■VF-nC3 software version up information

The changed specification points by software version up (V106→V108→V110) are followings.

■Errata sheet

This errata sheet provides updated information on VF-nC3 Instruction Manual E6581597①(Attached) and E6581595① (Detailed).

■Examples of connections when an external power supply is used (page B-11)

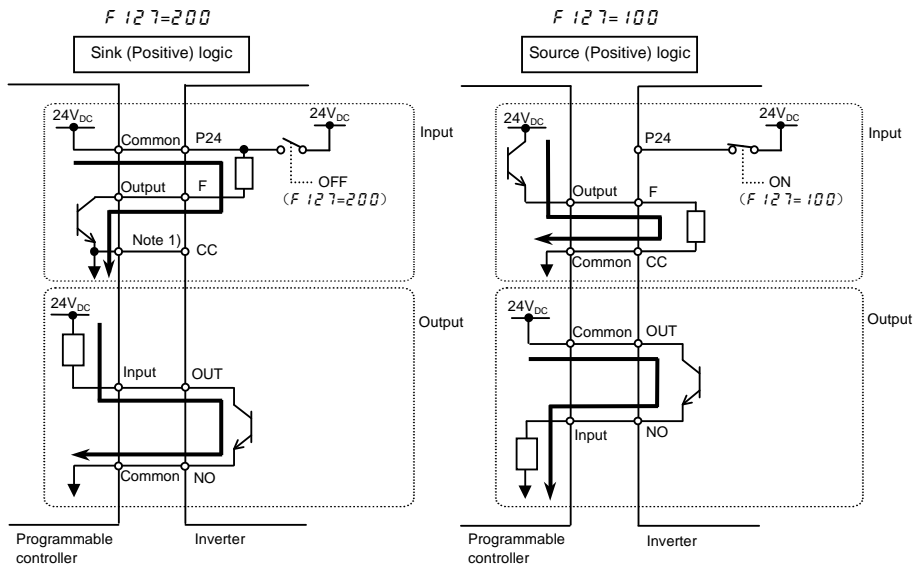
Updated information on VF-nC3 Instruction Manual E6581597①(Attached) and E6581595①(Detailed).

Note 1) Be sure to connect 0V of external power supply and CC terminal of the inverter.
